**Re: Windsong Subdivision
Map 6, Lot 167
CMA # 1325**

TO: Christian Smith, Beals Associates
FROM: Mark Connors, Planning & Community Development Director
RE: **Windsong Place Subdivision Staff Comments**

We are in receipt of review comments from CMA Engineers, dated April 1, 2024 and we offer the following responses to the noted comments. Each comment is followed by our response in **bold**.

**SUBDIVISION PLAN
FOR
KENNETH F. LANZILLO
IRREVOCABLE TRUST
OF
TAX MAP 6 LOT 167
189 BUNKER HILL AVENUE
STRATHAM, NEW HAMPSHIRE
COUNTY OF ROCKINGHAM**

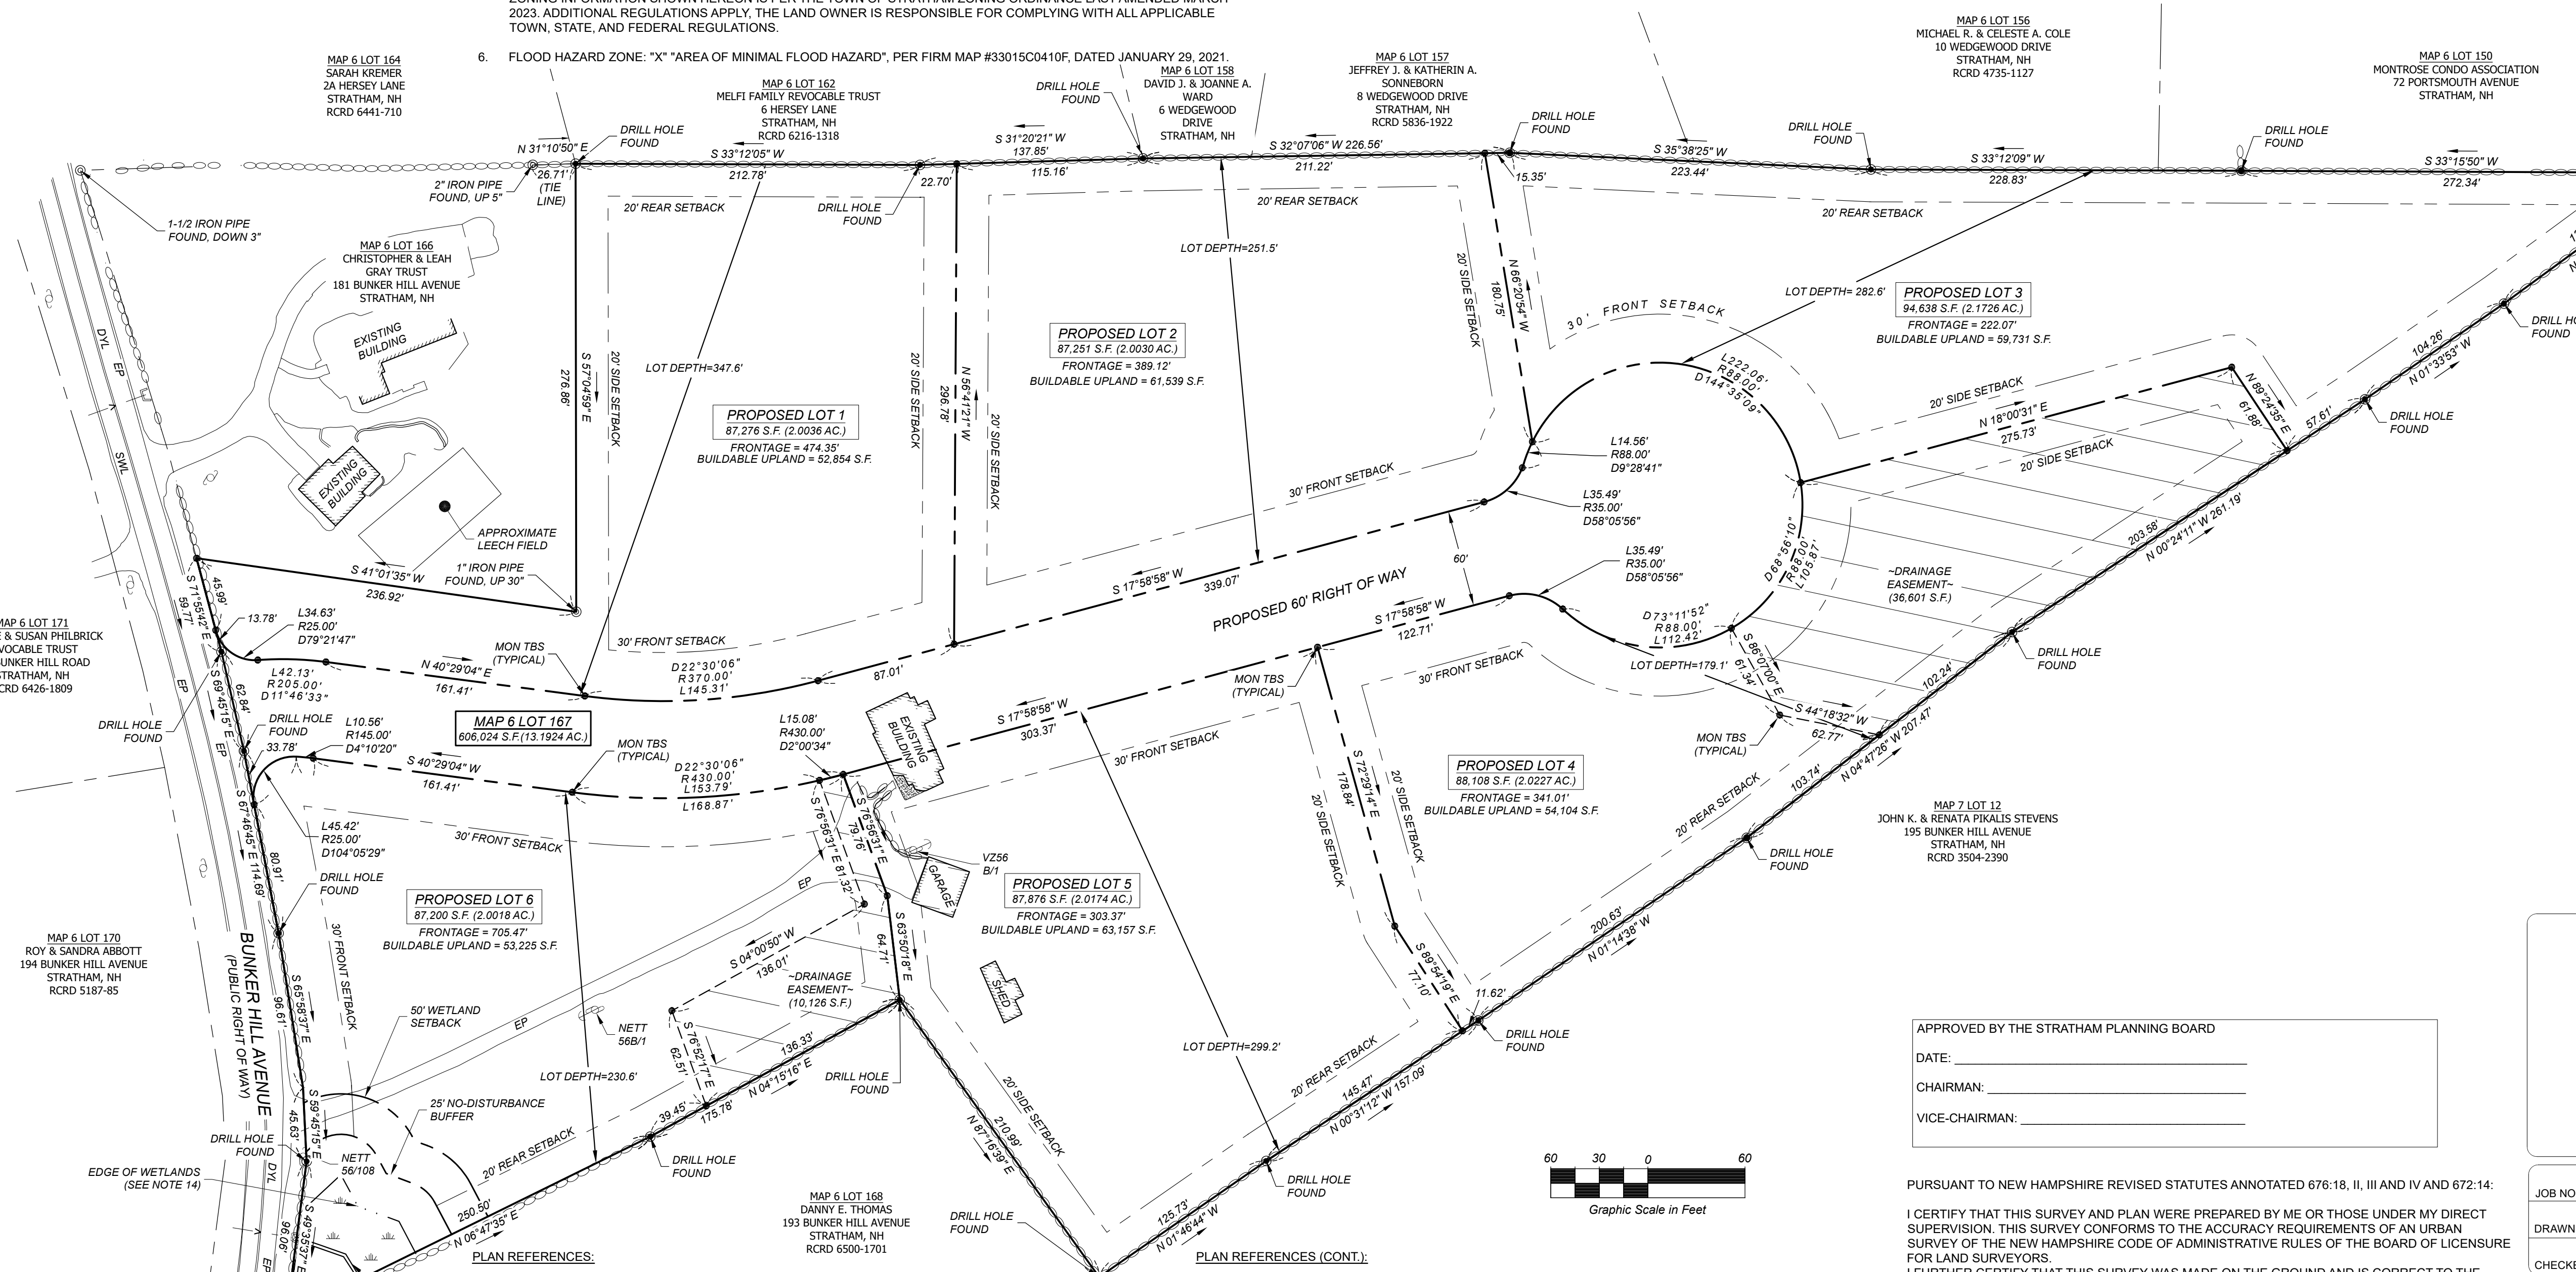
- a) The Subdivision Plan and Existing Conditions Plan erroneously show Bunker Hill "Road" instead of Ave.

- b) There are two Notes 4. On the Subdivision Plan.

Response: The note has been revised to reflect the area of disturbance which is below the AOT permit requirement.
- 2) A clear Purpose Statement should be noted as the first note of the Subdivision Plan. "The intent of this plan is to subdivide..."

Response: Plans have been revised to Avenue.

Response: The additional "4" has been removed.

Response: The purpose statement has been added.
- 3) The dimension for lot depth should be shown on the plan for each lot consistent with the definition as provided in the Zoning Ordinance.

| DEVELOPMENT PLAN | | | |

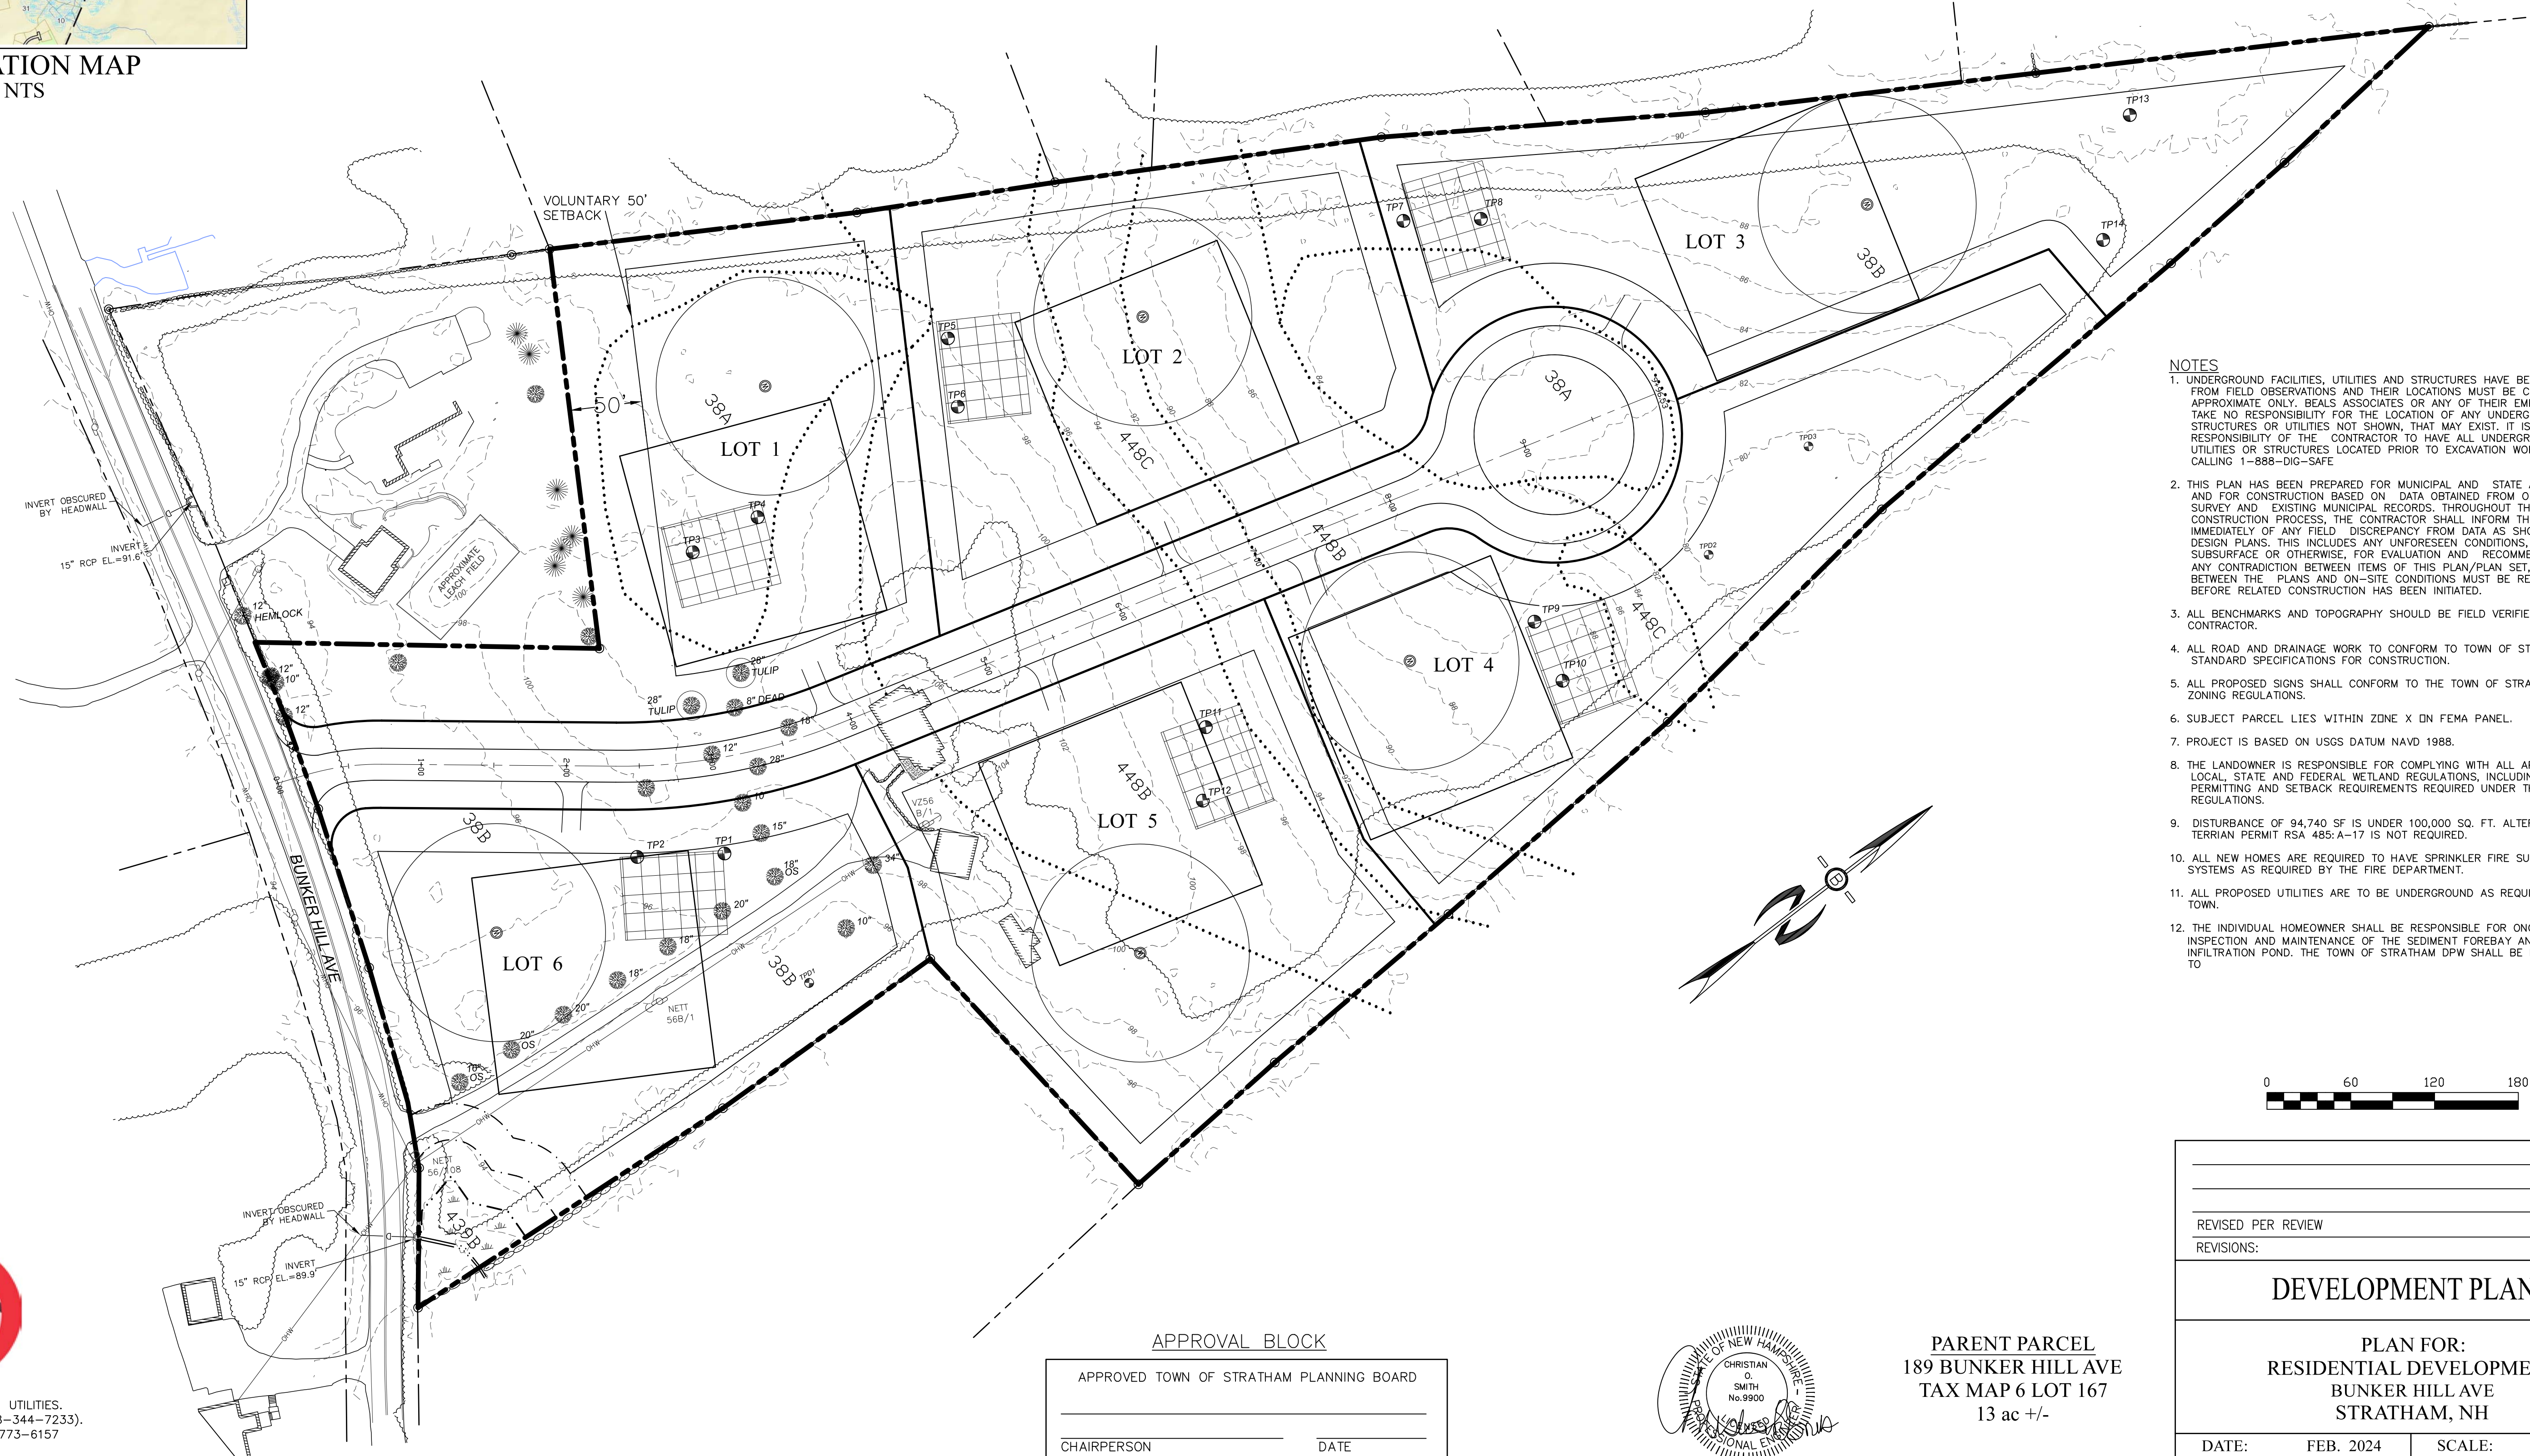
4.4.7b.i. – Note 10 on Sheet 3 indicates that all homes will have sprinkler systems, but each home is served by a private well. Are individual storage tanks proposed?

4.4.7b.i. – Note 10 on Sheet 3 indicates that all homes will have sprinkler systems, but each home is served by a private well. Are individual storage tanks proposed?

- e) Note 11 on Sheet 3 indicates utilities are proposed to be underground but these are not shown on the plan.

- 12) Staff would recommend renaming Sheet 3 as the development does not meet the statutory requirements to qualify as a site plan and may cause confusion.

- 13) Note 11 on Sheet 3 should be revised to note the type of sprinkler systems proposed and to note that they would fully serve all living spaces as previously indicated.

Response: If sprinkler systems will be provided over a water cistern, pressure tanks will be provided in the basements.

Response: These will be provided when the utility company provides their response.

Response: The title has been revised to Development plan.

Response: When a manufacturer is selected by the applicant, that information will be provided to the Town. Sprinkler systems, if supplied over a water cistern, will fully serve all living spaces.

INFILTRATION POND DETAIL
 NOT TO SCALE

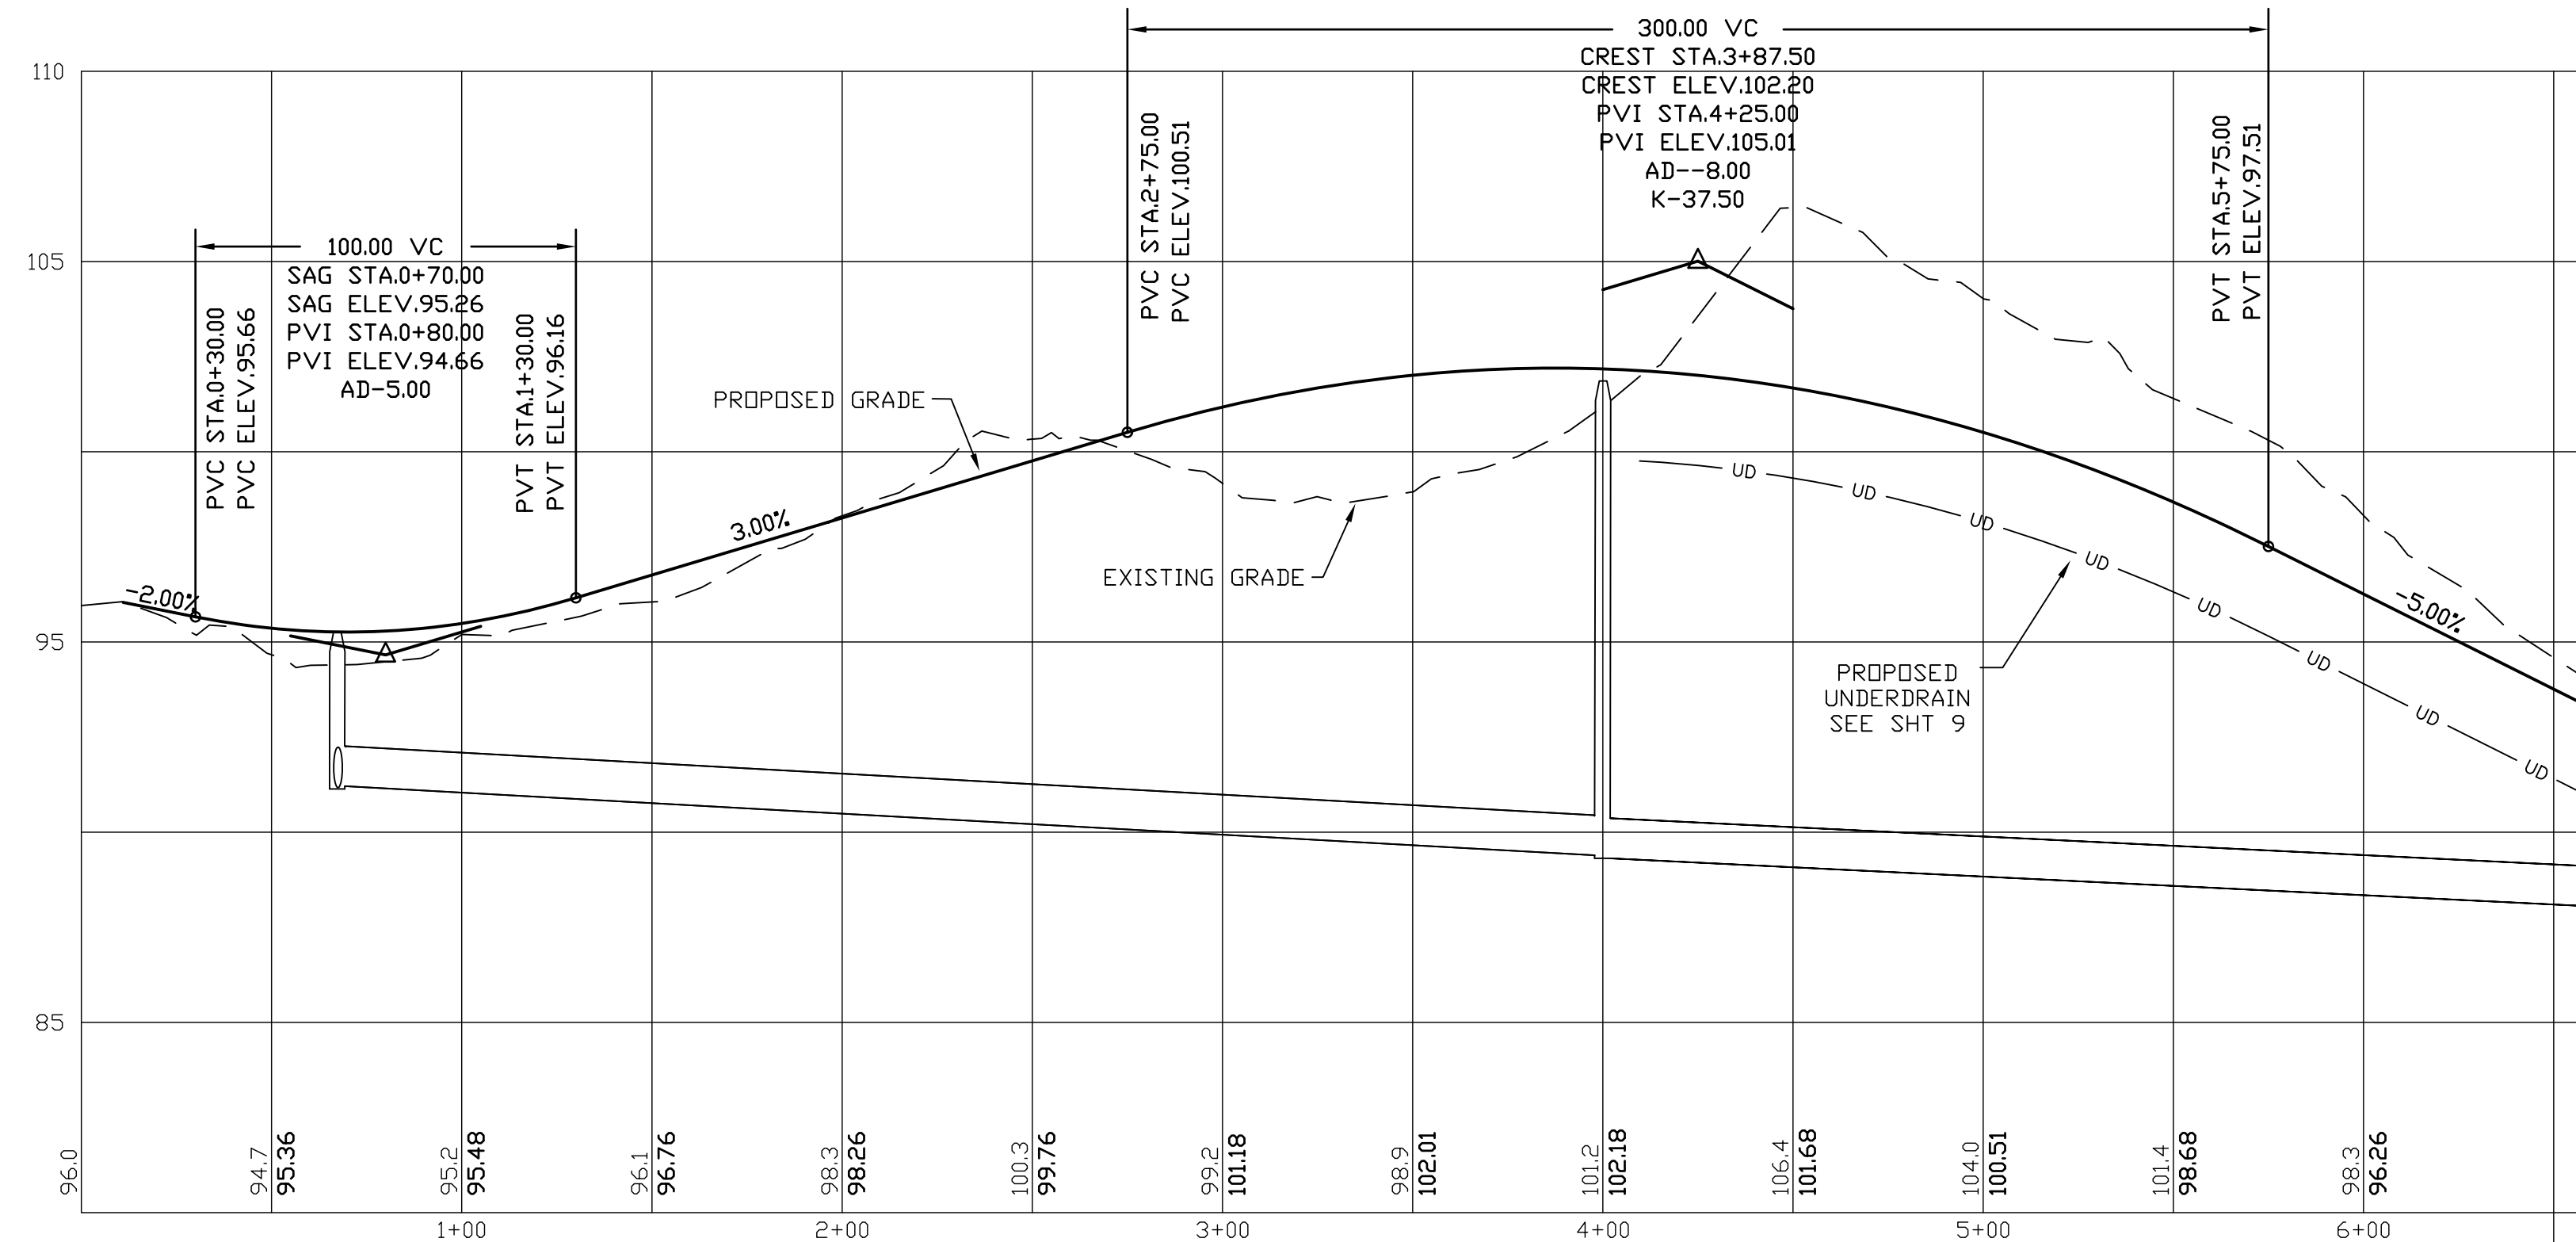
- b) Infiltration pond #2 does not have 3' or greater separation from groundwater. Additionally, the Infiltration Pond Detail on Sheet 5 should show the required 6" of coarse sand or pea gravel. Verify that the pond can hold the 50-year, 24-hour storm without overtopping.

Response: Per NHDES regulations, separation can be reduced to 1 foot if treated prior to entering the practice.
- c) The applicant should complete the appropriate BMP worksheet for the infiltration practices. This worksheet includes important design information including the design infiltration rate, time to drain, separation from the seasonal high-water table, peak elevations of storm events, etc.
